SEISMIC MARGINS STUDY  
J. Kovic needs to review the portions of Attachment 2  
relative to UNITED STATES geotechnical engineering

NOTE FOR: George Lear, Chief SGEB  
THRU: P. T. Kuo, Section Leader, Section B, SGEB  
FROM: Frank Rinaldi, Structural Engineer, Section B, SGEB  
SUBJECT: MEETING SUMMARY - TERA's IDCVP

Re: Docket Nos. 50-329 OM, OL and 50-330 OM, OL  
Midland Nuclear Plant - Units 1 and 2  
Independent Design and Construction Verification (IDCV) Program  
Meeting Summary

130.30 With respect to Volume II, Seismic Margin Review: Reactor Containment Building, forwarded by your letter of March 30, 1983, provide the following information:

FIGURE Q&amp;R 130.30.2-17. OTSG Point 33 Z-DIR 4% Damping

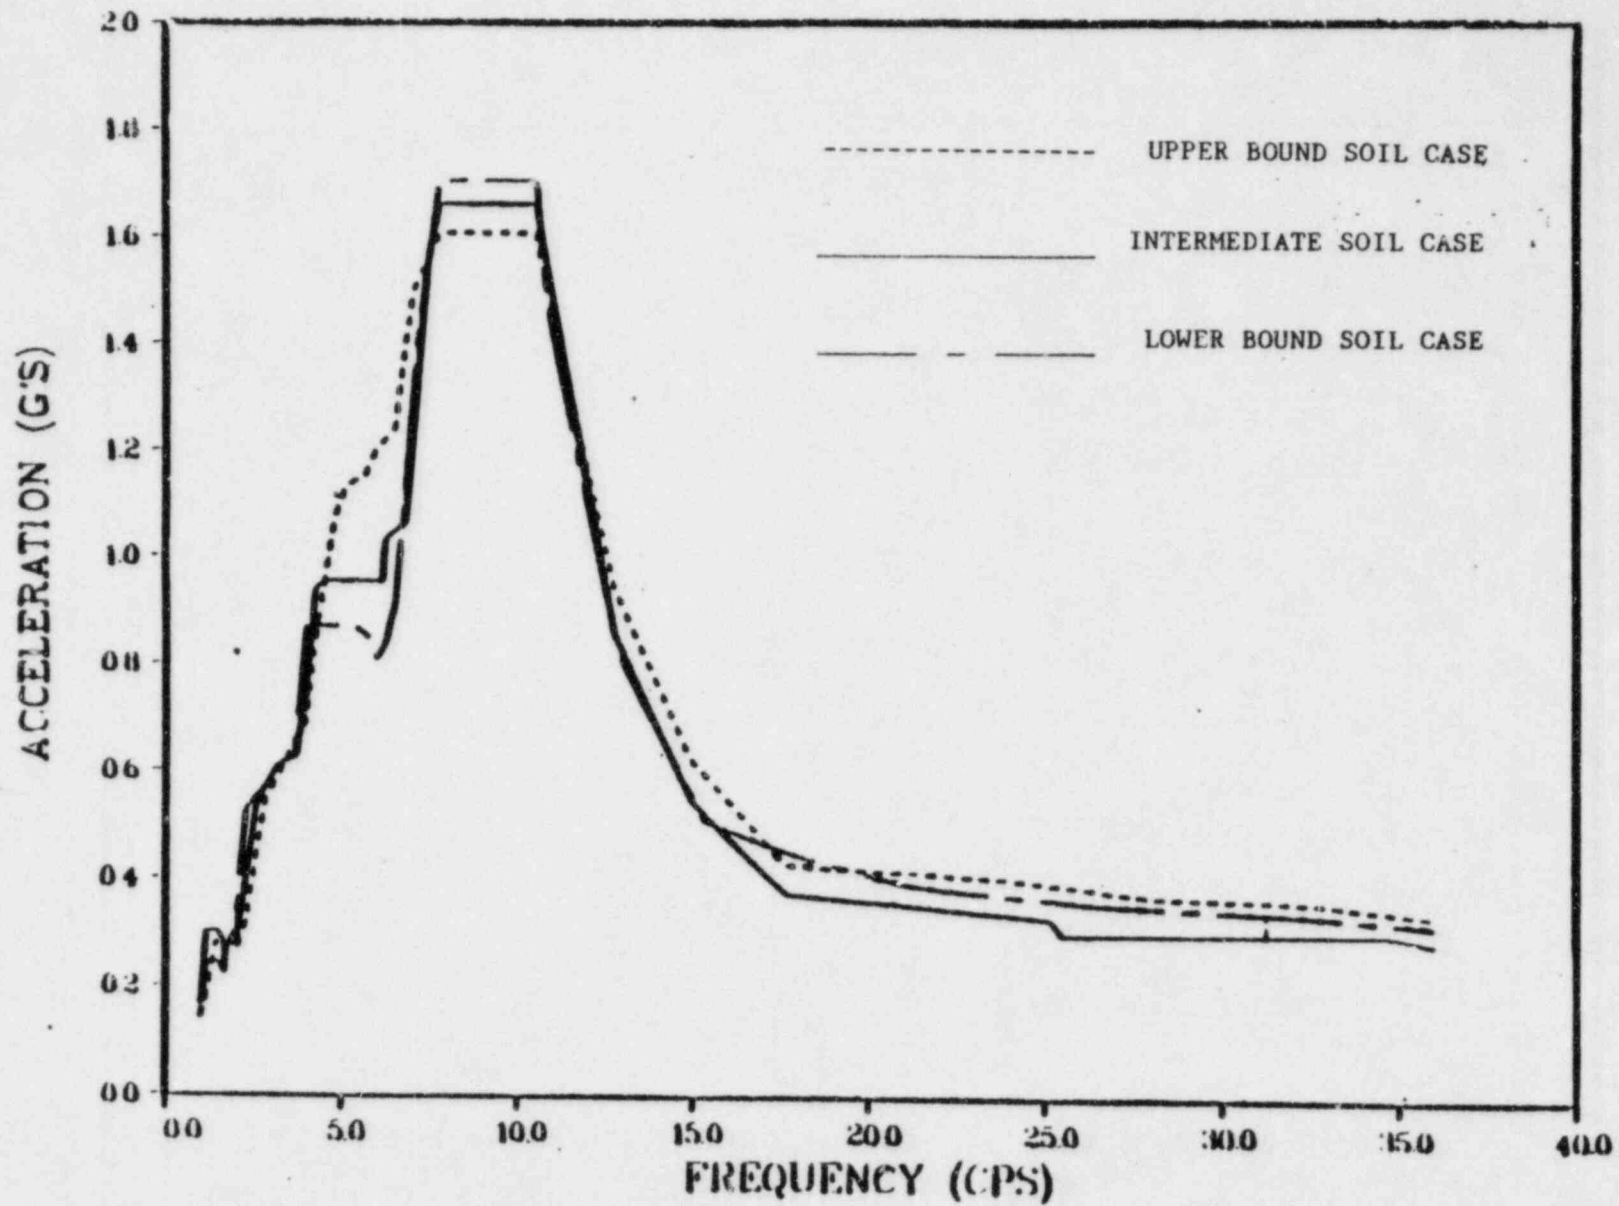
Section 5 of the report presents in-structure response spectra for internal structures. However, none are provided for the steam generators and the reactor vessel. Please provide these missing spectra or justify their omission.

Volume II was written to describe the analysis of the reactor containment buildings and their internal structures. In addition, Volume II presents the in-structure response spectra for use in evaluating equipment attached to the structure. Seismic input at the Nuclear Steam Supply System (NSSS) interfaces in the reactor containment buildings was developed by Structural Mechanics Associates, Inc. (SMA) for the Seismic Margin Earthquake. This input was defined in terms of translational and rotational time histories and response spectra for each of the three soil cases studied. The requested seismic response spectra were generated by Babcock & Wilcox (B&W), the NSSS Vendor. Since the B&W generated seismic response spectra are only an intermediate step in the Balance-of-Plant piping analysis, they were not included in Volume VIII. Figures Q&R 130.30.2-1 through Q&R 130.30.2-7 present the schematic of the reactor vessel model used by B&W and the seismic response spectra for 4 percent of critical damping. Similarly, Figures Q&R 130.30.2-8 through Q&R 130.30.2-17 are presented for the steam generators.
